SECTION 00910

ADDENDA

SONOMA CLEAN POWER AUTHORITY ADVANCED ENERGY CENTER TENANT IMPORVEMENTS

ARTICLE 1 - ADDENDUM #3

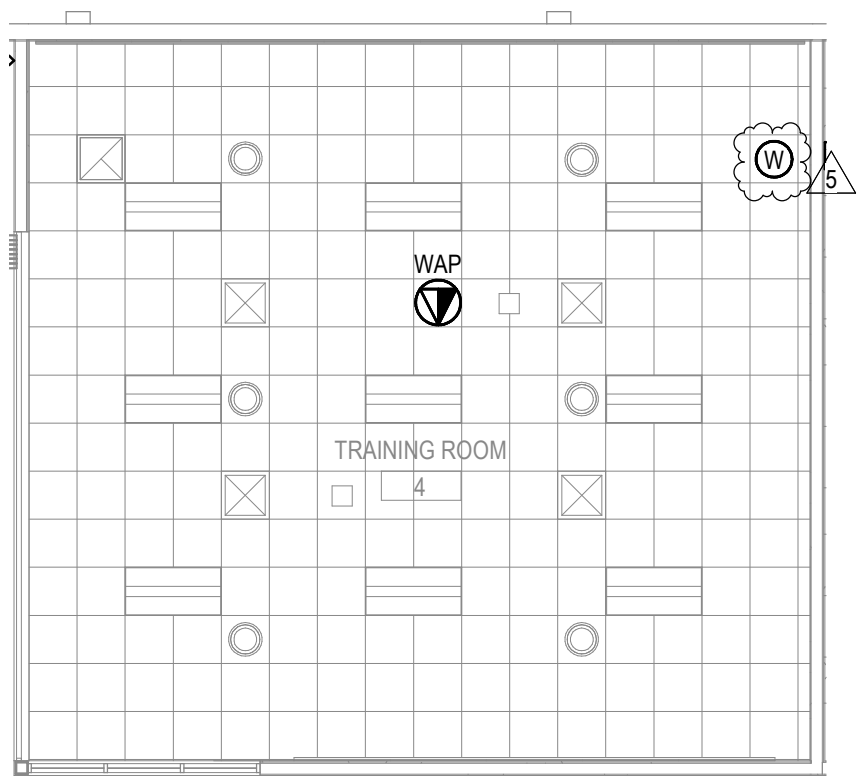
- U. Add drawing TSK-03 (Moved ACAMS Reader to Mullion) to the "Bid Set Combined" set of Construction Drawings for TLCD Project Number: 18077.00.
- V. Add drawing TSK-04 (Added Wireless Hub) to the "Bid Set Combined" set of Construction Drawings for TLCD Project Number: 18077.00.
